Statutory Comments (07/10/2025)

Your ref: LCC/2023/0030
Our ref: LCC.D2.2023.0030
Date: 7th October 2025

Application no: **LCC/2023/0030**

Address: **Land off Bourbles Lane, Preesall**

Job No:	220503	Drawn By:	J.L.
Date:	Oct 2024	Checked By:	J.L.
Scale:	1 / 200 @ A1	Drawing No:	220503 / 04.2 / A

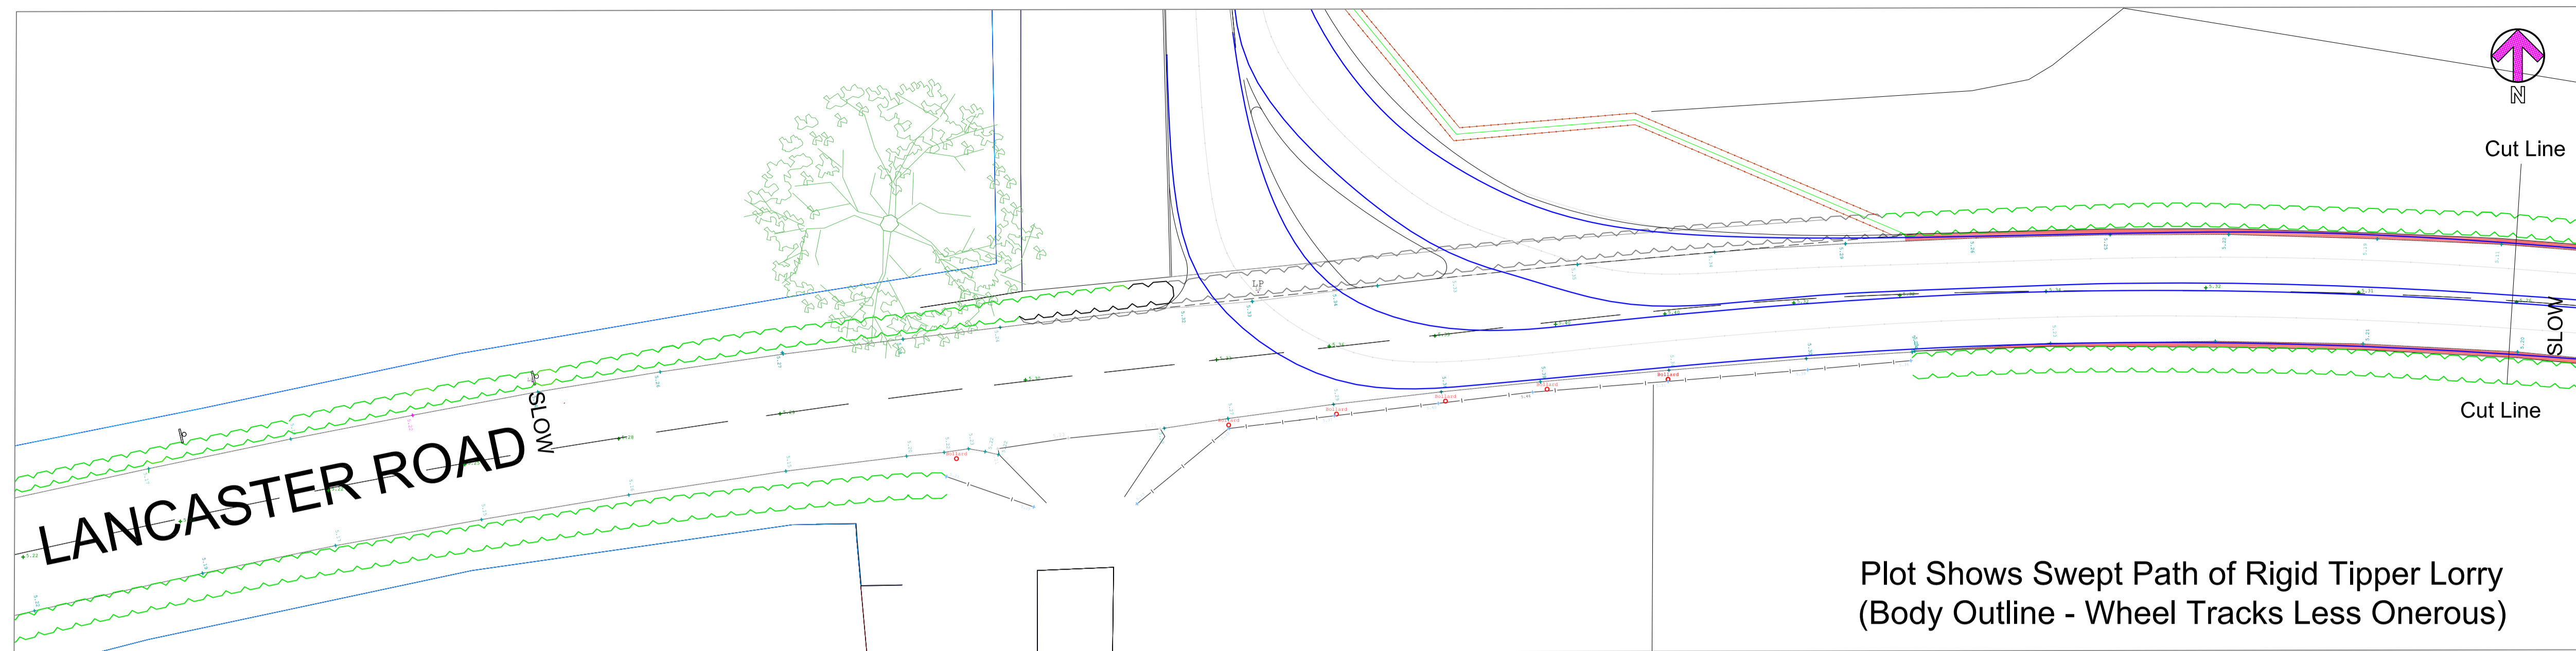
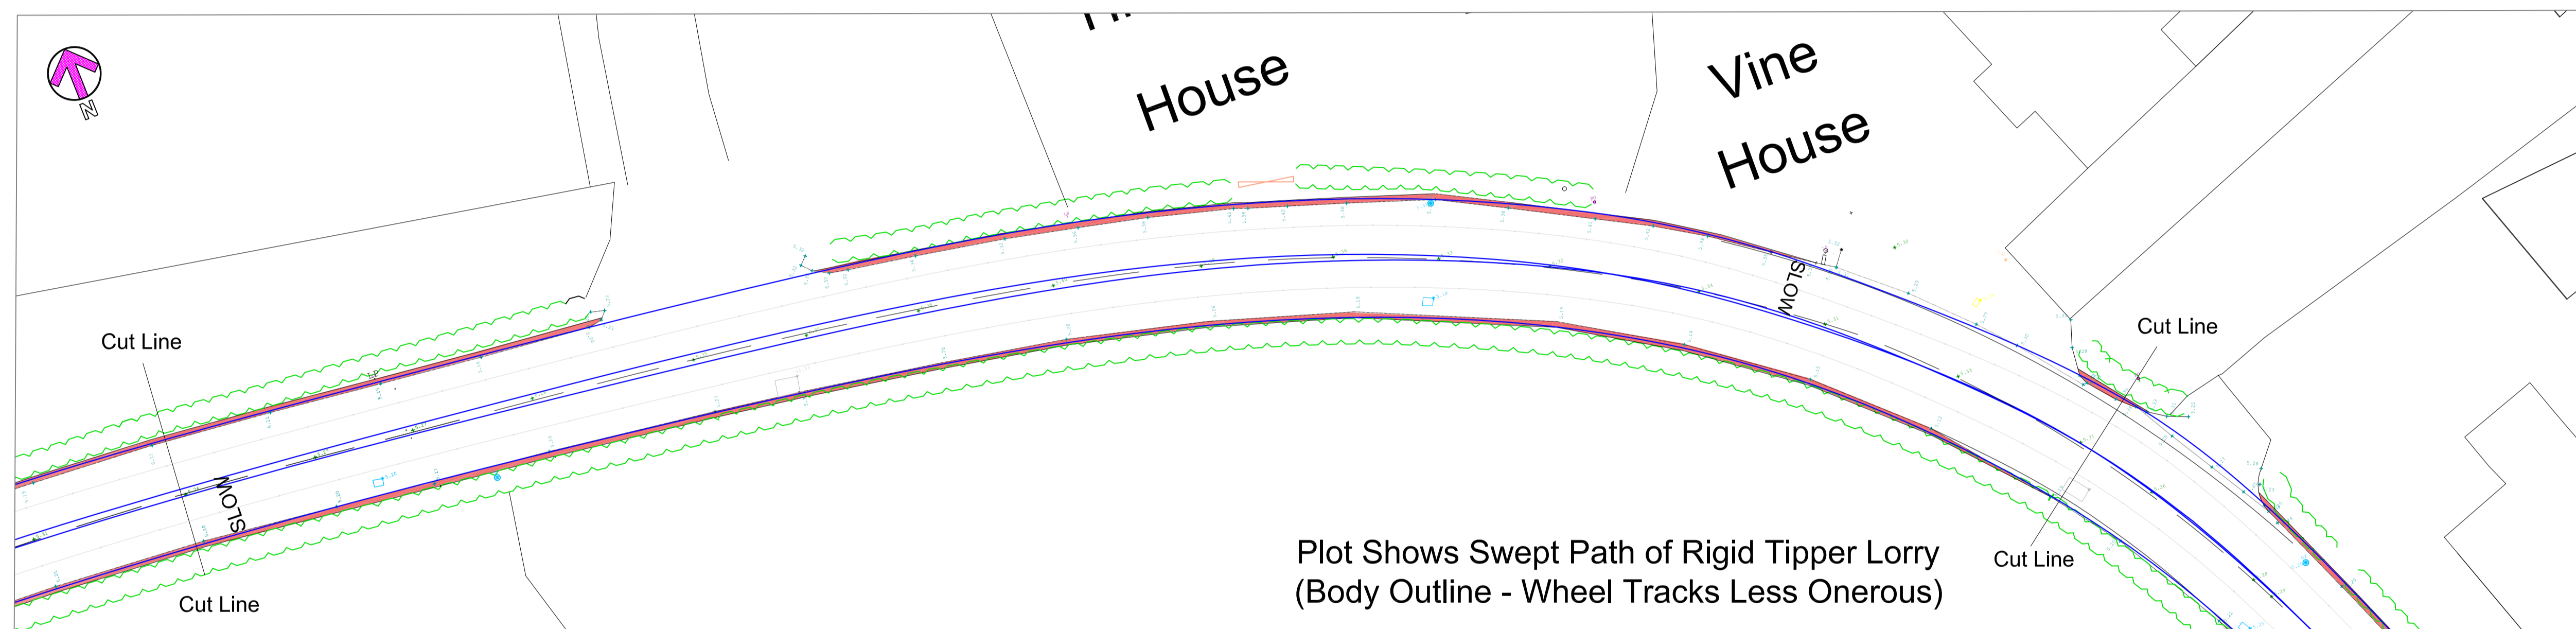
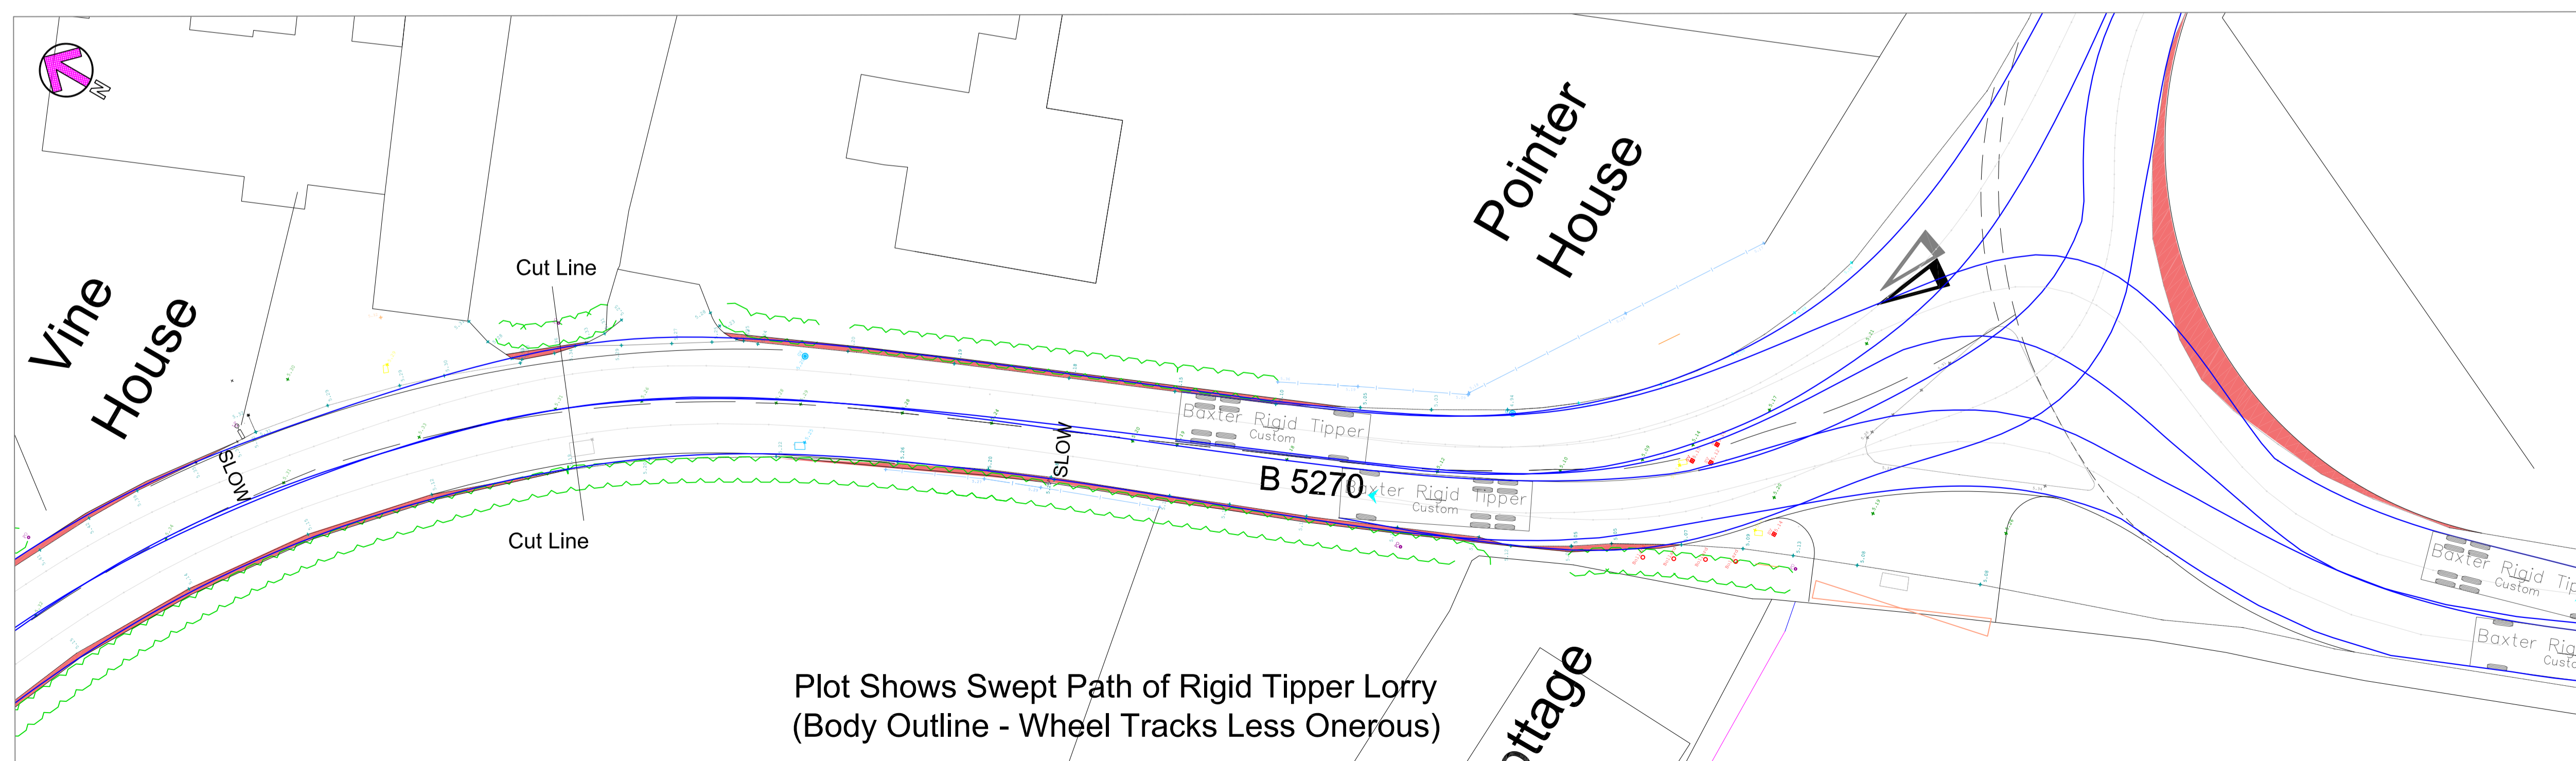
The Agent has provided Turner Lowe drawing number 220503/04.1/A titled "HGV Manoeuvres Sheet 1" and Turner Lowe drawing number 220503/04.2/A titled "HGV Manoeuvres Sheet 2." Within the TS, the Agent states in paragraph 4.12, that "*with the widened carriageway, there would be clearance between 2 HGV's passing over virtually all of the length of Lancaster Road from the site access to the A588. The exception is the bend at Vine House.*"

The Agent has provided Turner Lowe drawing number 220503/04.1/A titled "HGV Manoeuvres Sheet 1" and Turner Lowe drawing number 220503/04.2/A titled "HGV Manoeuvres Sheet 2." Within the TS, the Agent states in paragraph 4.12, that "*with the widened carriageway, there would be clearance between 2 HGV's passing over virtually all of the length of Lancaster Road from the site access to the A588. The exception is the bend at Vine House*".

Job No:	220503	Drawn By:	J.L.
Date:	Feb 2024	Checked By:	J.L.
Scale:	1 / 100 @ A1	Drawing No:	220503 / 06.1 / A

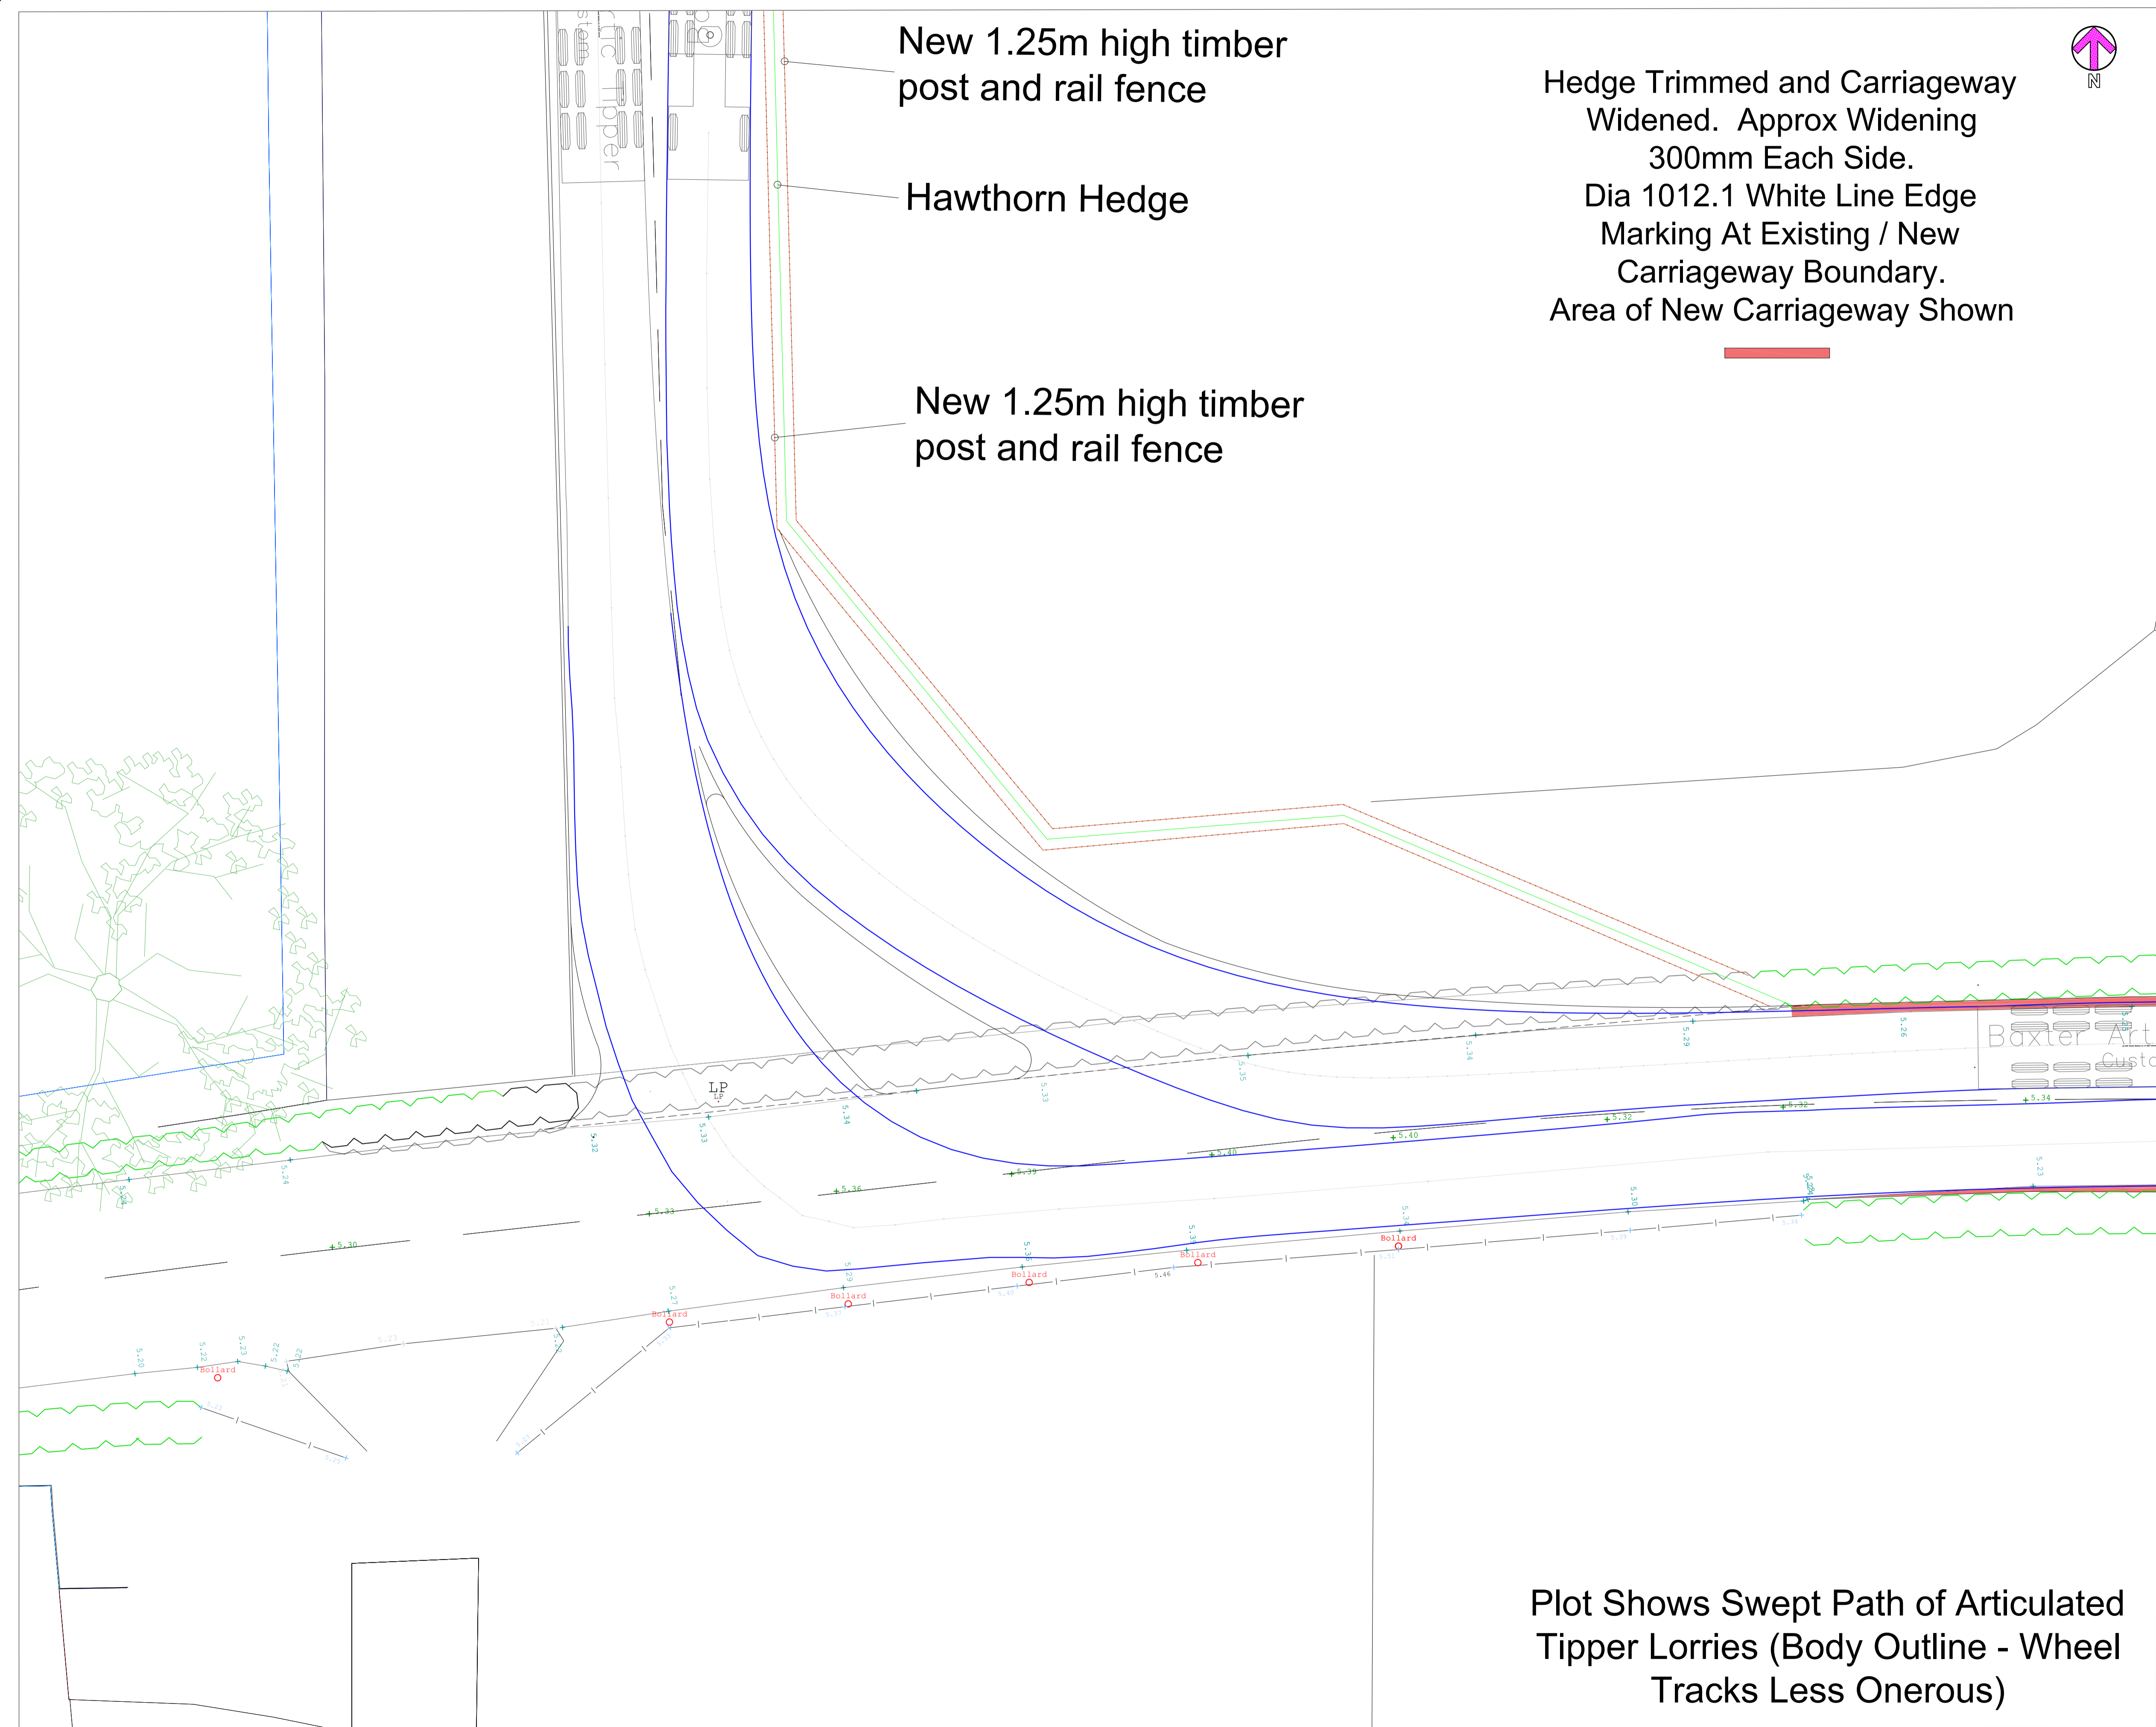
To ensure that the access width can cater for articulated HGV movements, the Agent has provided Turner Lowe drawing number 220503/06.1/A titled "Access Arrangements HGV Manoeuvres Sheet 1" and Turner Lowe drawing number 220503/06.2/A titled "Access Arrangements HGV Manoeuvres Sheet 2." The LHA have reviewed the updated drawings and note that the supplied internal swept path analysis does not take account of the wing mirrors of the HGVs. Therefore, the LHA are unable to fully assess whether two-way HGV movements can occur along the full extents of the access track.
